Wisconsin Department of Transportation

Proposal #14: 1130-64-71, WISC 2025135
Appleton – De Pere
I-41 Mainline, STH 96 – RR Bridge
IH 041
Outagamie County

This is Addendum No. 02, which provides for the following:

ADDENDUM NO. 02
1130-64-71, 1130-64-72 and 1130-64-87
November 26, 2024

Addendum No. 02
ID 1130-64-71/72
Added Sheet 97A
November 26, 2024

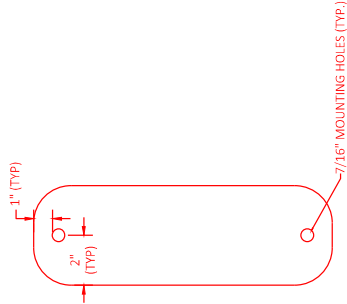
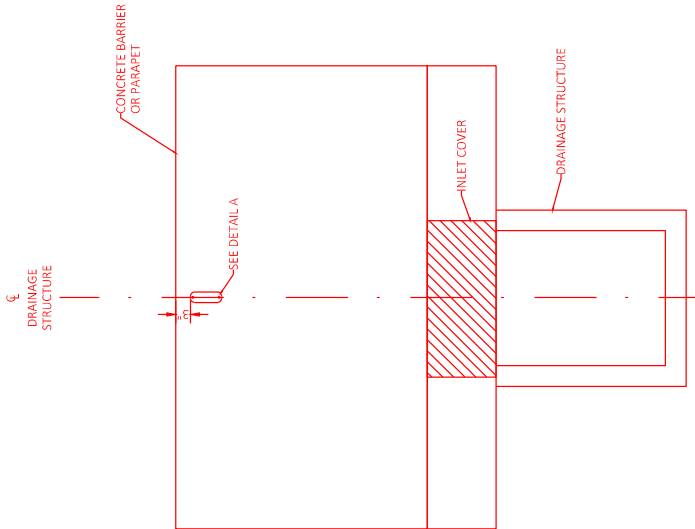
Added Plan Sheets	
Plan Sheet	Plan Sheet Title (brief description of why sheet was added)
97A	Construction Details: Provides details for installation of inlet marker.
832A	Miscellaneous Quantity: Added quantity for Inlet Marker.
950A	Miscellaneous Quantities: Added quantity for Inlet Marker.
1315A	Standard Sign: Added to provide details for inlet marker sign referred to in sheet 97A.

DETAIL A - MARKER MOUNTING

INLET MARKER
NOT TO SCALE

MARKER MOUNTING NOTES:
STANDARD SIGN W5-53S, SIZE 2M (SIGN PLATE W5-53S, LOW INLET MARKER)
3/8" X 1" STAINLESS STEEL ANCHOR WITH NYLON AND STAINLESS STEEL WASHERS.
ANCHORS SHALL HAVE HEXAGONAL HEADS.
SEE SIGN PLATE A4-8 FOR ADDITIONAL INFORMATION REGARDING WASHERS.

Addendum No. 02
ID 1130-64-71/72
Revised Sheet 101
November 26, 2024

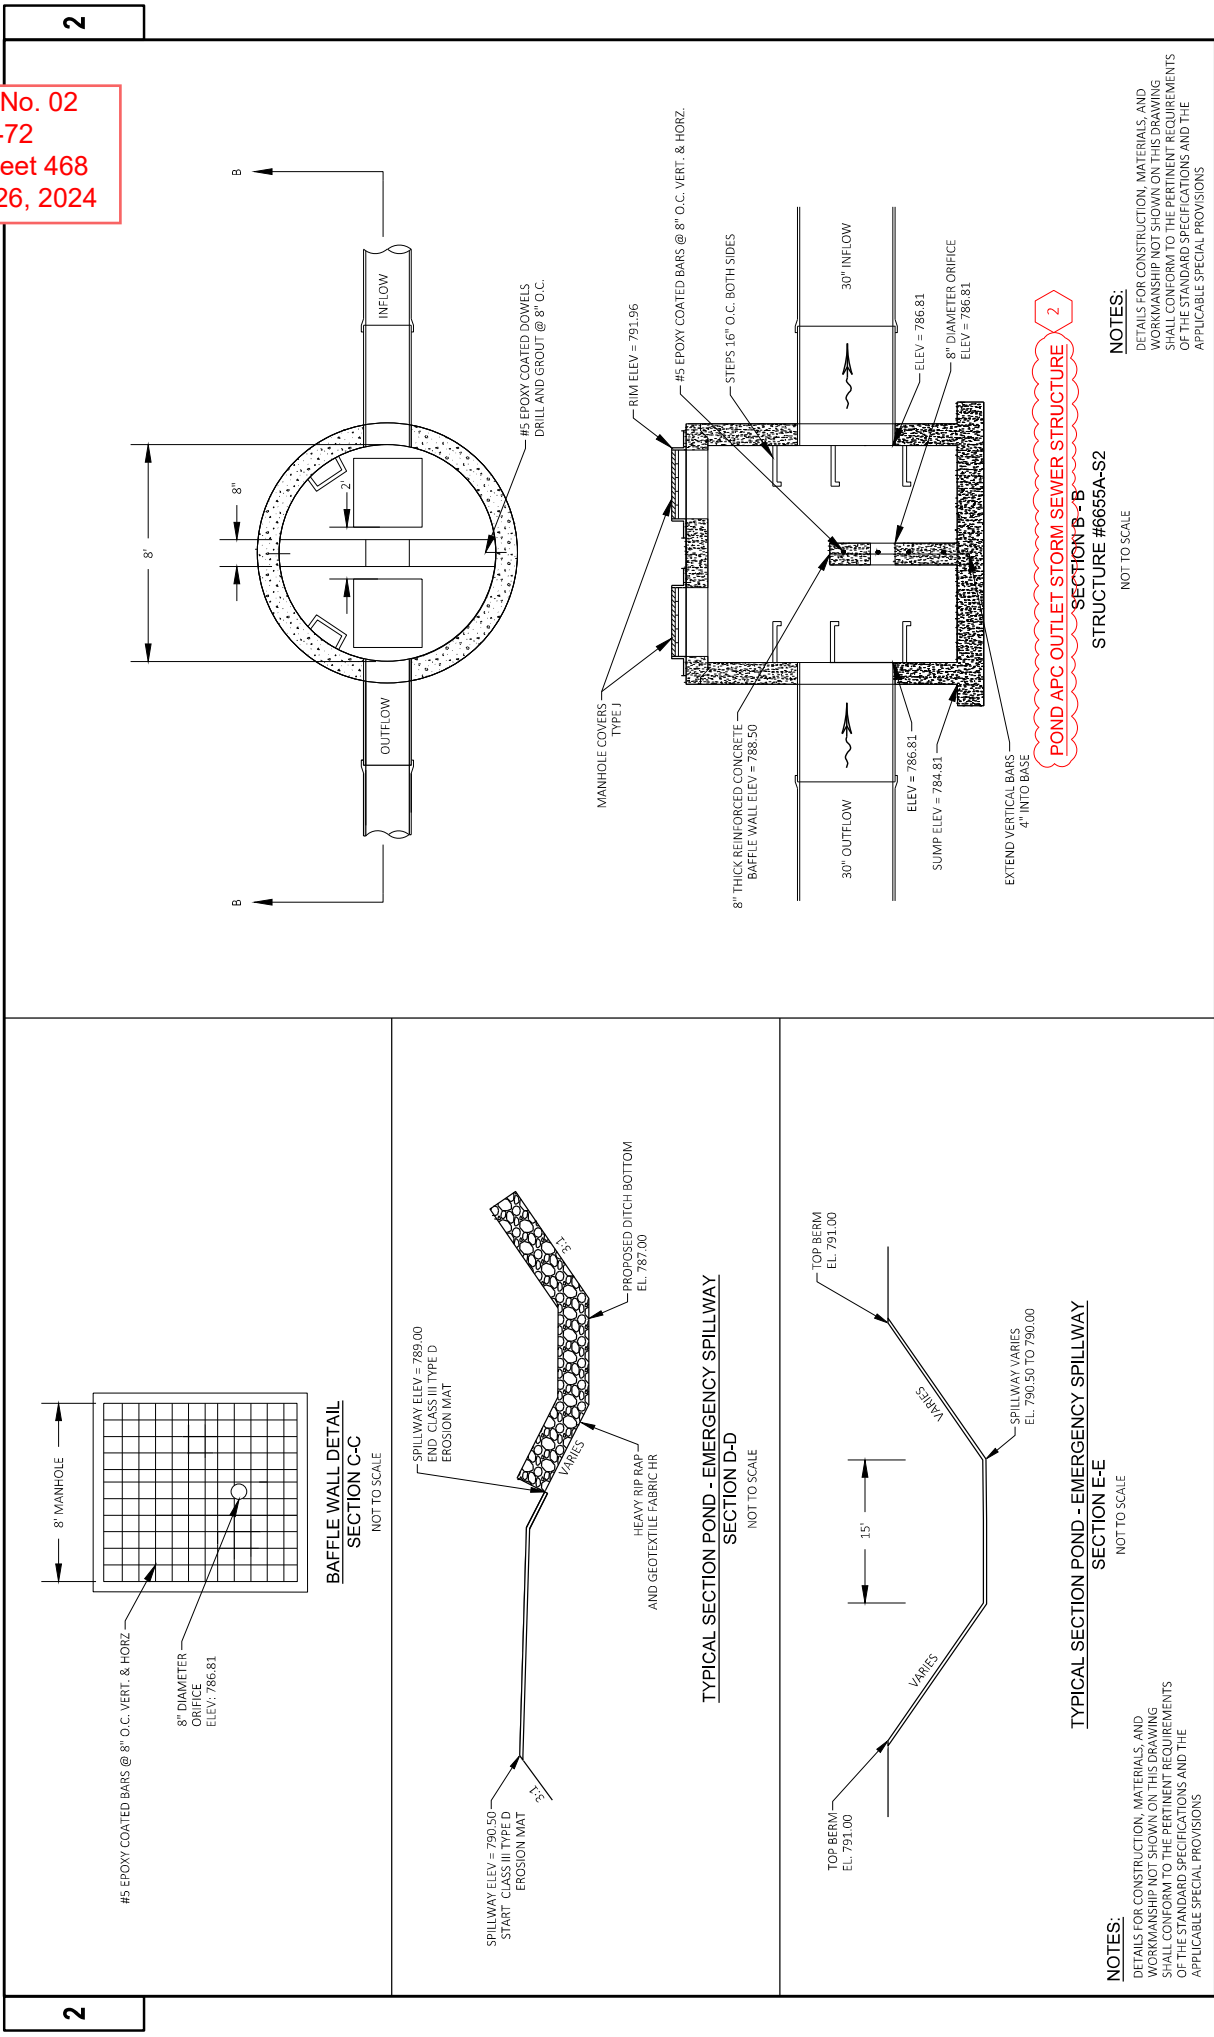
Revised Plan Sheets	
Plan Sheet	Plan Sheet Title (brief description of changes to sheet)
99	Construction Details – Drainage: updated note (1) to refer to standard spec.
101	Construction Details – Drainage: Updated location for removing casting bolts.
468	Stormwater Management – Pond APC Details: Revised name of outlet control structure.
829	Miscellaneous Quantities: Updated/added quantities
862	Miscellaneous Quantities: Updated Excavation Common and Roadway Embankment for Pond APC.
1630	Earthwork Data: Updated end areas and volumes for Pond APC.

SPECIAL PROVISION ARTICLE 13.11 - REMOVING CASTING BOLTS LOCATIONS - PROJECT 1130-64-72
